ADDENDUM 3

PROJECT NAME: Frank Garrett HVAC Project

PROJECT NO: 35-00282-02-03

Date: 11/27/2023
Client: MARMONMOK ARCHITECTURE
Project Name: FRANK GARRETT COMMUNITY CENTER RENOVATION-PACKAGE 2
Project Number: 23002

SHEET NO.
M101

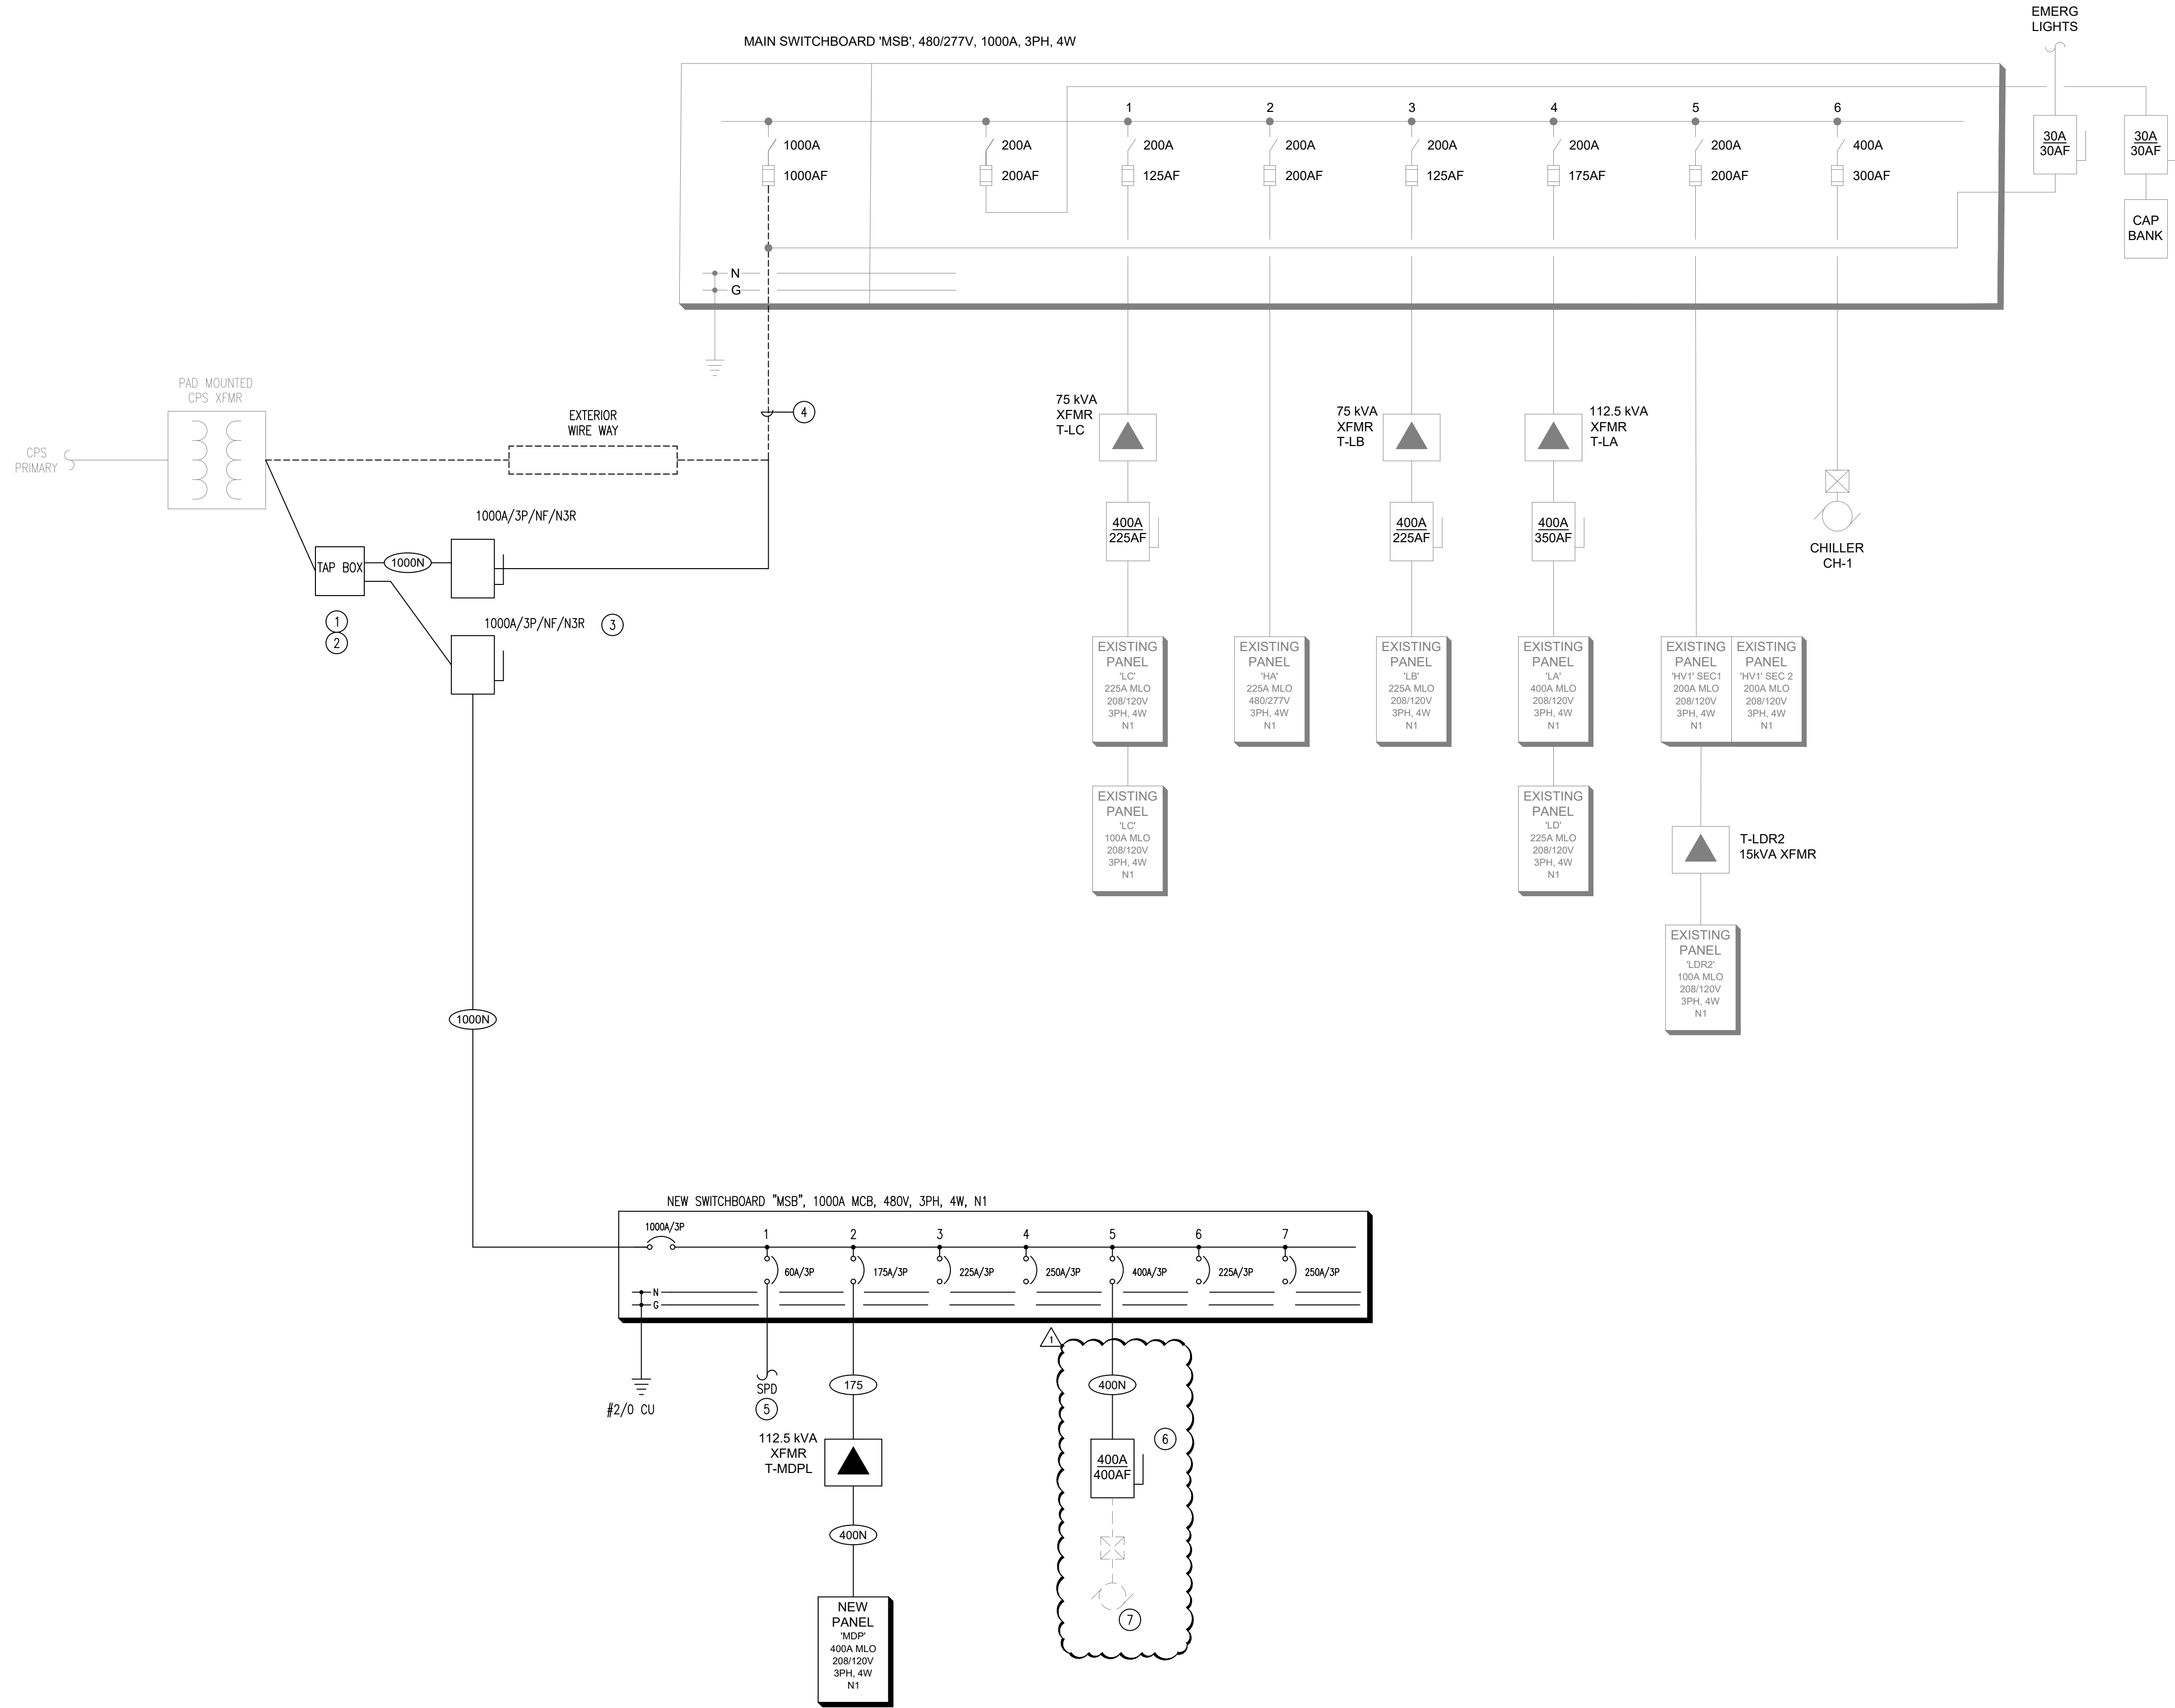
RE: Plan Sheet M101:

- Item 1: Added keyed notes.
- Item 2: Added demolition work.
- Item 3: Added new work.
